TOWN OF ELIOT, MAINE

PLANNING BOARD AGENDA

DATE: Tuesday, September 20th, 2022
TIME: 6:00 P.M.

- b) 771/787 Main Street (Map 6/Lots 43, 44, 154), PID # 006-043-000, 006-044-000, 006-154-000, PB22-09: Clover Farm Subdivision (8 lots) – Preliminary Plan Review

SCALE: 1" = 30'	APPROVED BY:	DRAWN BY: MJS
DATE: 08/23/22		REVISION DATE:
JOB NO: C174-21	FILE: MAIN ST REV BASE.DWG	SHEET: 3

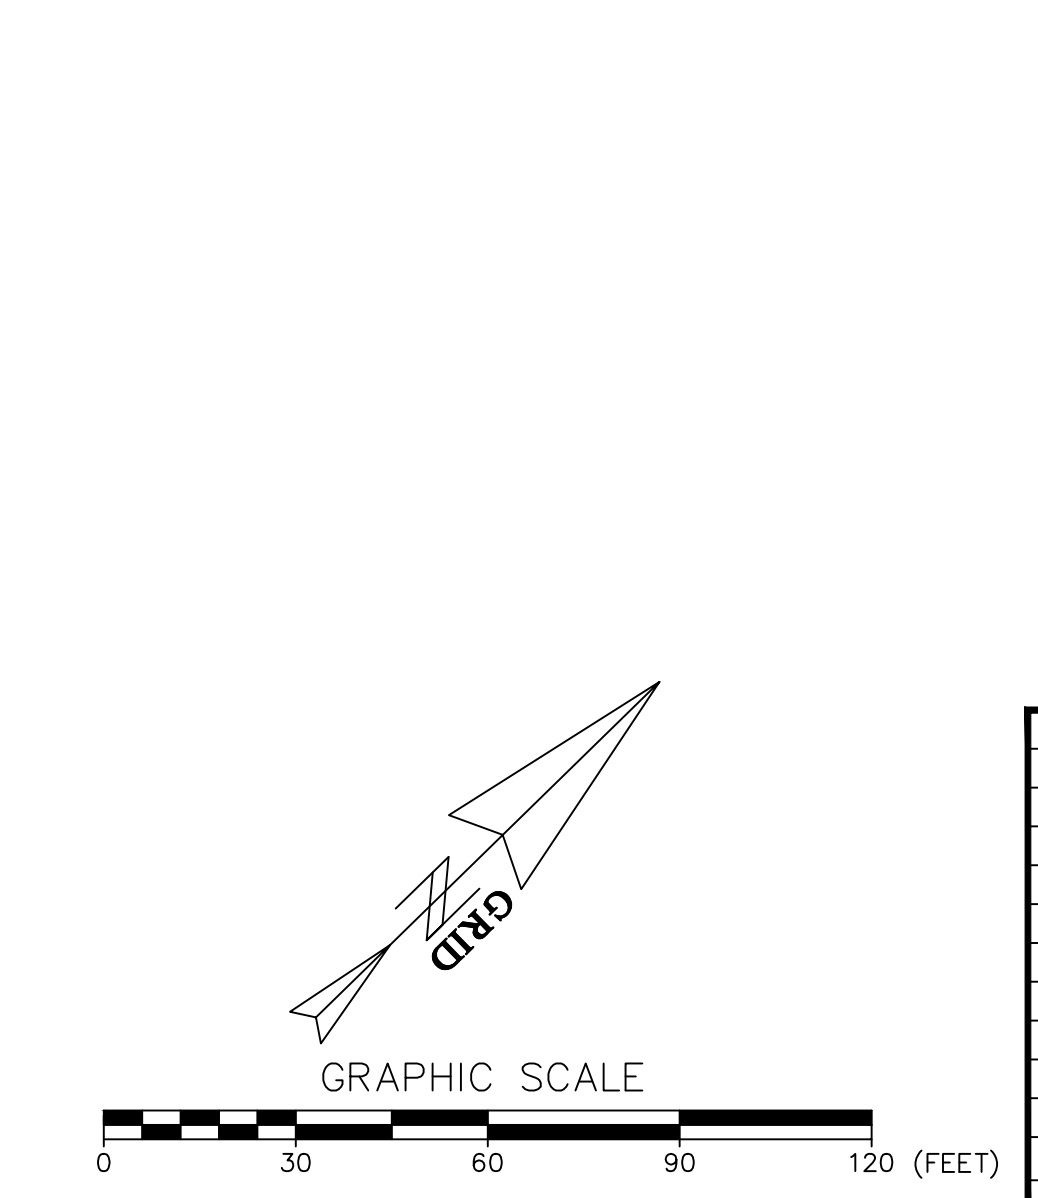
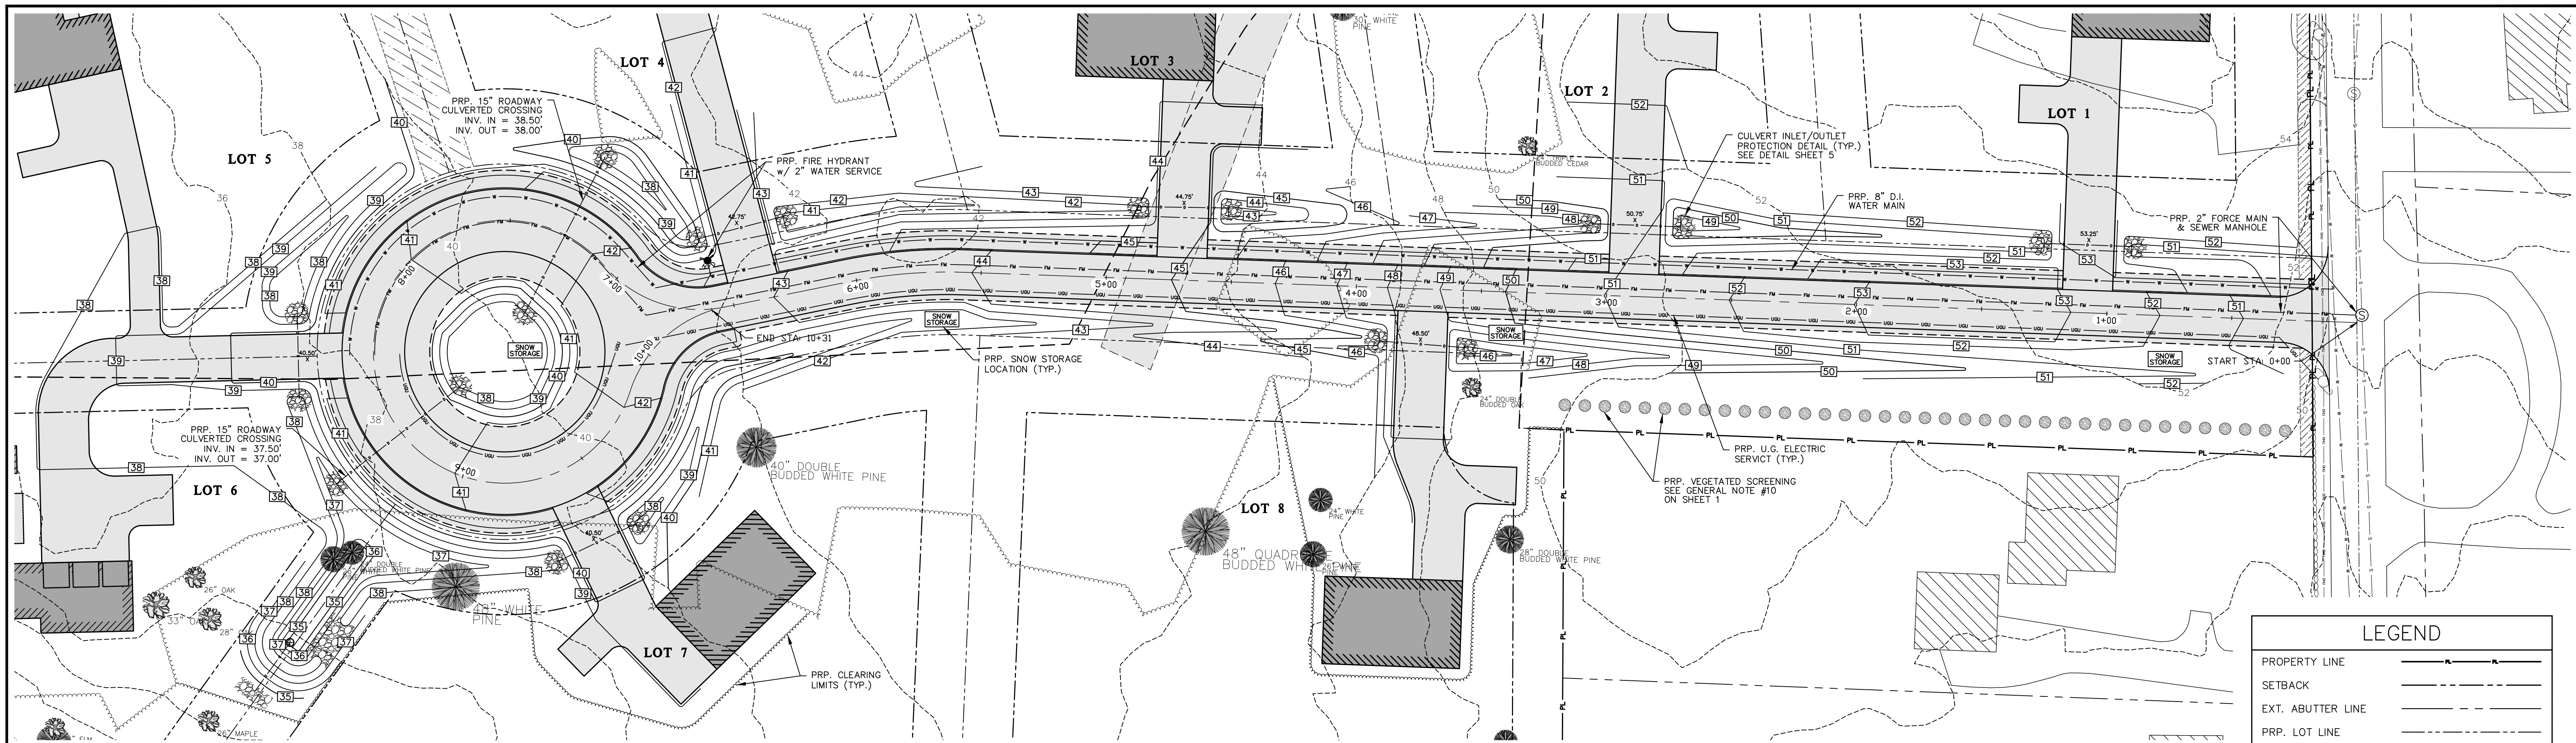
Per 41-215(a), a landscape plan is incorporated into Sheet 3 – Grading & Utilities Plan. Existing tree lines, proposed clearing limits, and large trees (24+ in. DBH) to be preserved are shown. If the PB deems necessary, you may consider requiring the preservation of lesser diameter trees (down to 10 in.) per 41-215(a). As noted above, grading is moderate (0 to 4 ft.) and primarily associated with the road/cul-de-sac, swales, stormwater detention pond. Per 41-215(b), the proposed arbor vitae buffer along the southeastern edge of the development continues to be depicted and is described in Sheet 1, Note 10. The PB may wish to further comment on the location and type of trees in this buffer.

The subdivision proposes to connect to municipal water and sewer. The 8” water main would be under the northwest half of the road. A fire hydrant is proposed near the Lot 4 driveway, at the base of the cul-de-sac. The 2” sewer force main would be under the middle portion of the road, leading out to the public gravity line on Main St. Water and sewer details are on Sheet 6. A pump station is to be located after input from the Kittery Sewer Dept. Review comments from Kittery Water District, Kittery Sewer Dept., and the Fire Chief are anticipated but have not yet been received at the time of this report. Further review of the sewer main size and sufficiency may be needed per 41-218(a), which requires a min. 8” diameter main.

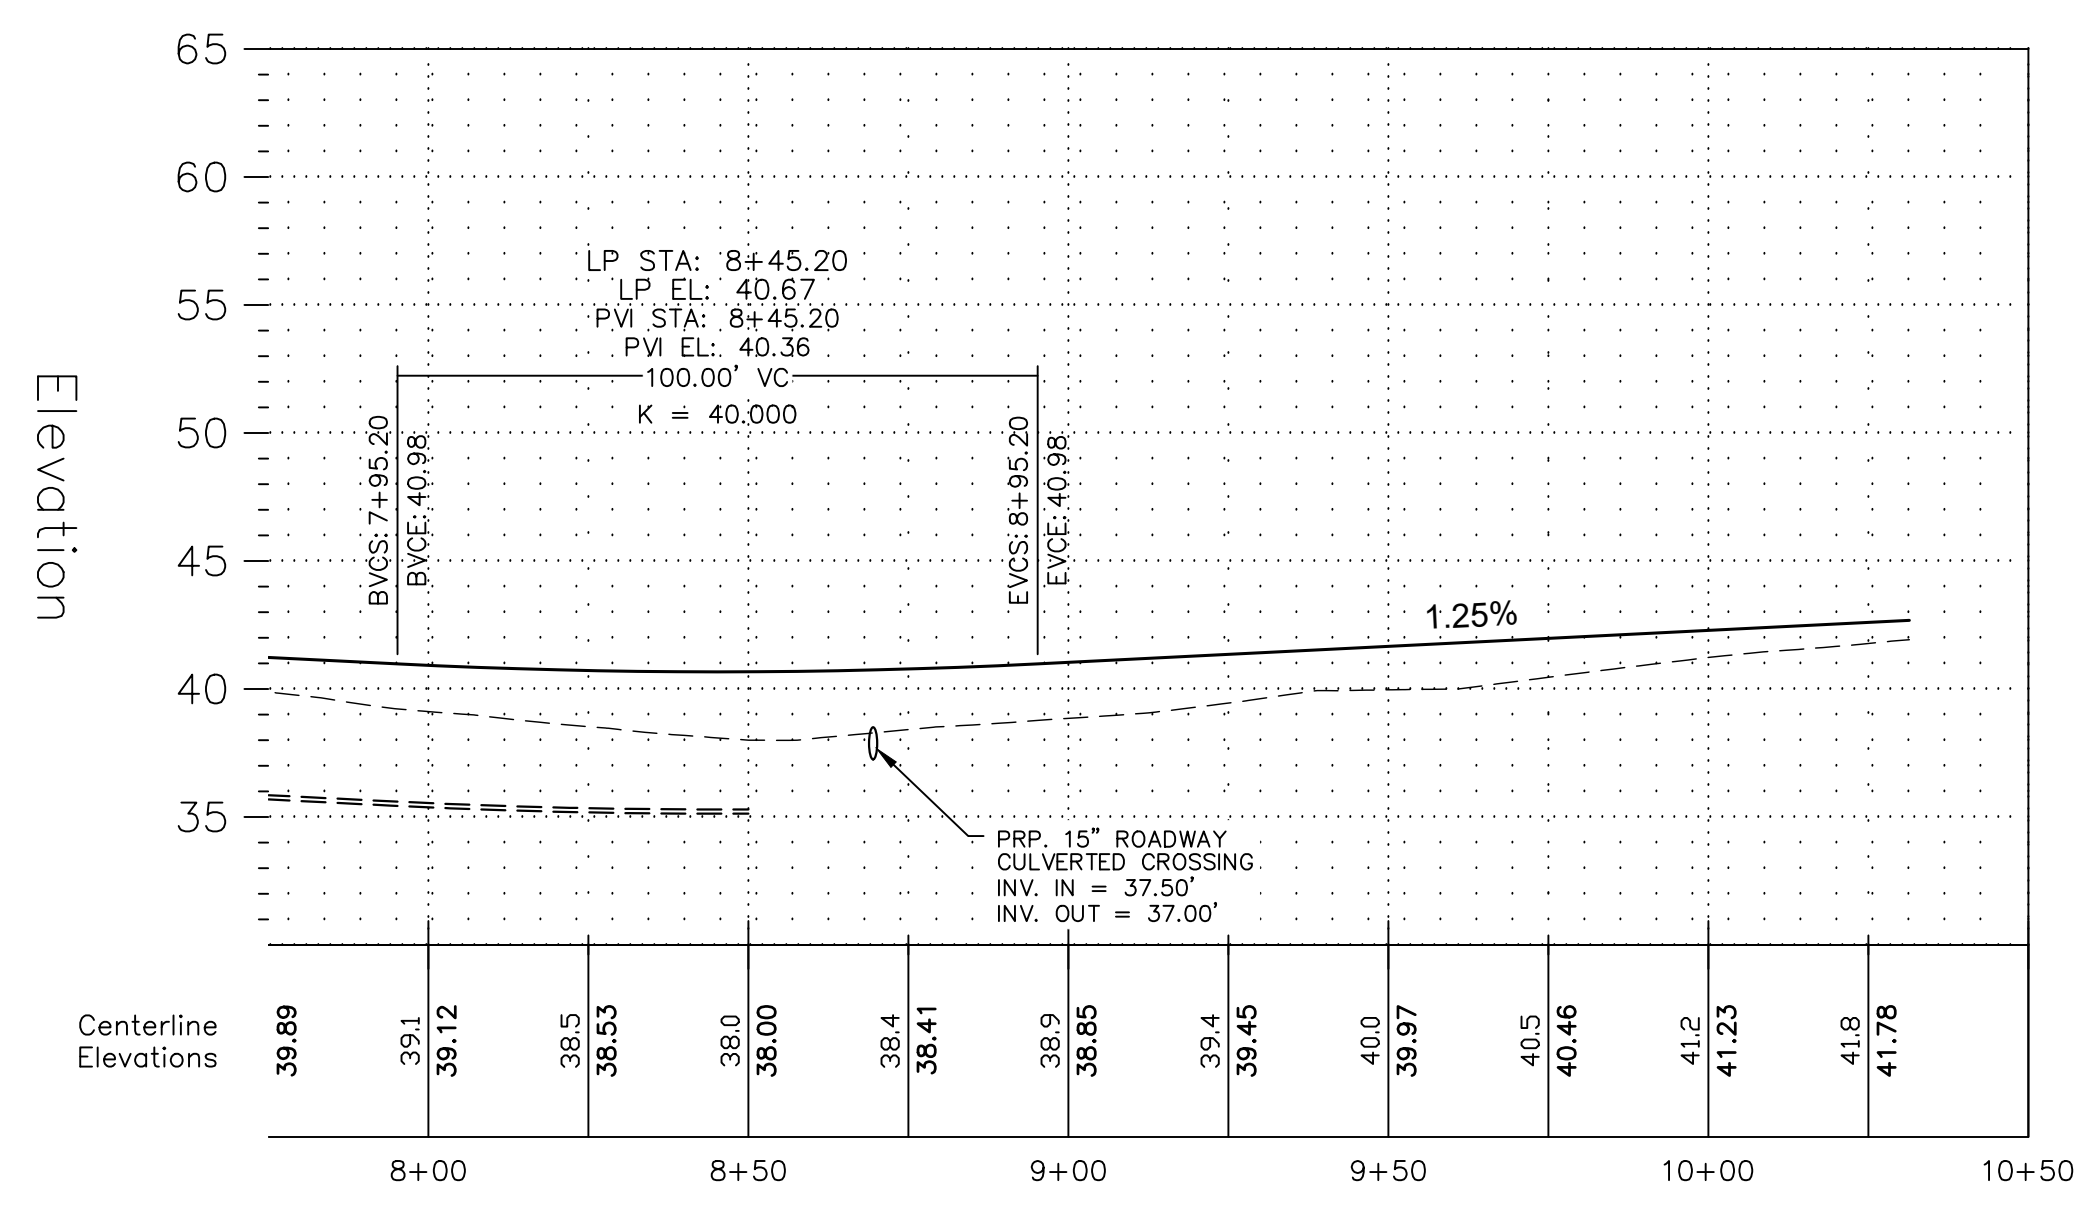
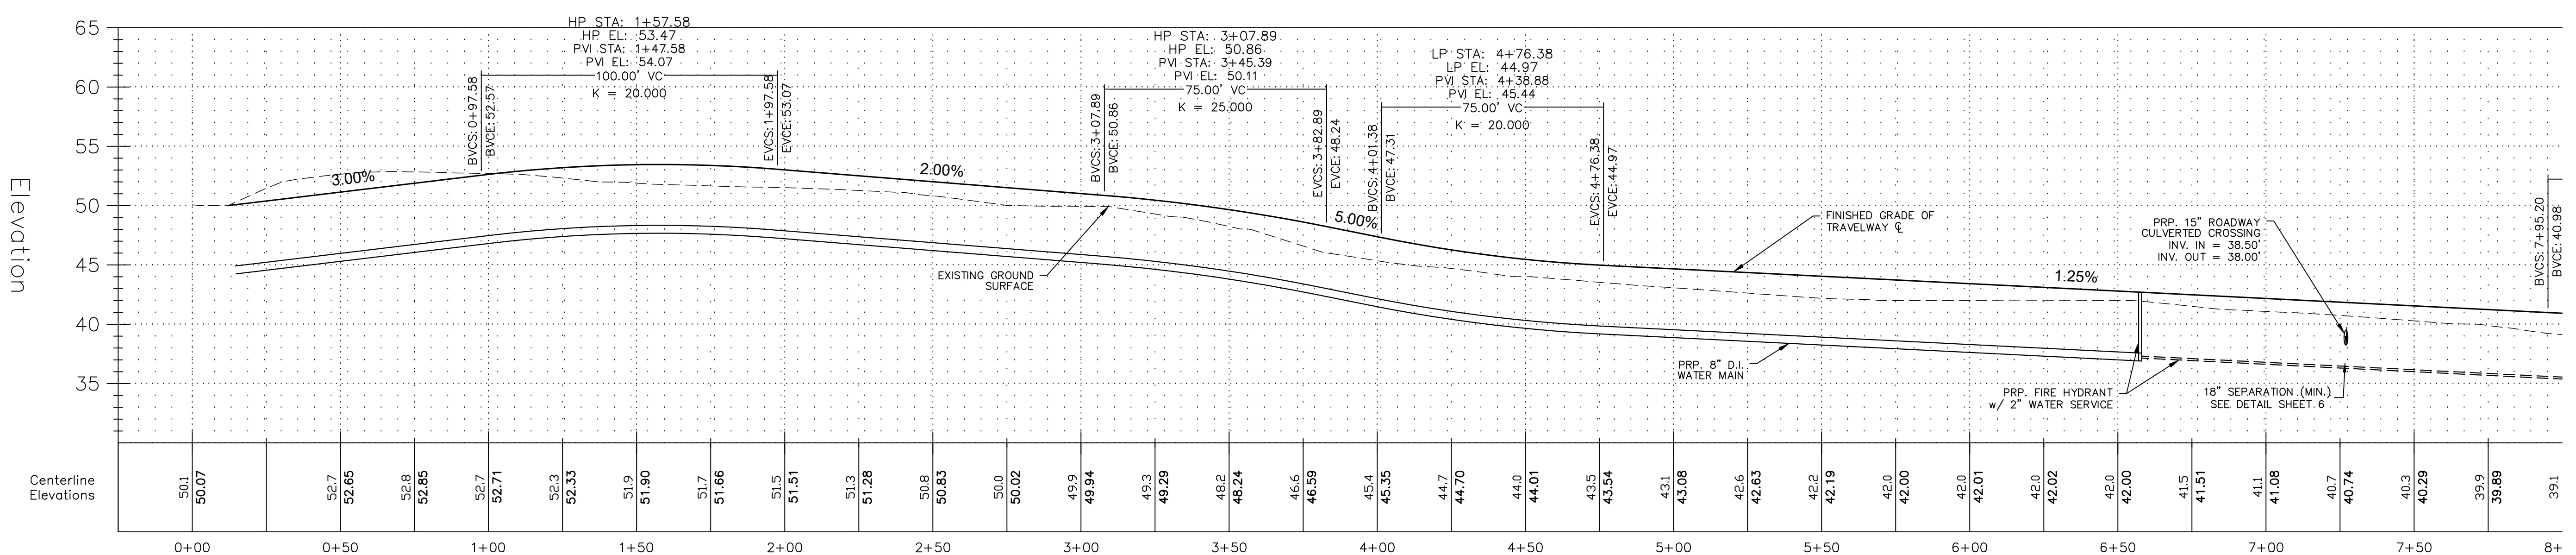
Minor road (<15 lots) street design standards (37-70)	Planner review
Min. right-of-way: 40 ft.	Met. 50-75 ft. R/W shown on plan. First ~300 lf has been widened to allow for shifting of road to the north to avoid utility pole and bring it further away from, and screen, abutting property (Map 6, Lot 42), plus accommodate a 5 ft. sidewalk.
Min. width of traveled way: 18 ft.	Appears to be met. Site plan (Sheet 1) and site detail (Sheet 6) show 18 ft. width.
Min. width of shoulders: 2 ft.	Met. Site plan (Sheet 1) and site detail (Sheet 6) show 2 ft. shoulder on side without sidewalk.
Sidewalk width (if used): 5 ft.	Met. 5 ft. sidewalk proposed on northwest side of the road and around the cul-de-sac [41-221(a)(4)]. See various plan sheets and the detail on Sheet 6.
Min. grade: 0.5%	Appears to be met. Grade is 1.25% to 5% as shown in the roadway profile on Sheet 4.
Max. grade: 8.0%	Appears to be met. See above.

The underground utility line is shown under the southeast half of the road. See Sheet 4 and trench/conduit detail on Sheet 6. The PB did not require 10% open space reservation per 41-220(c).
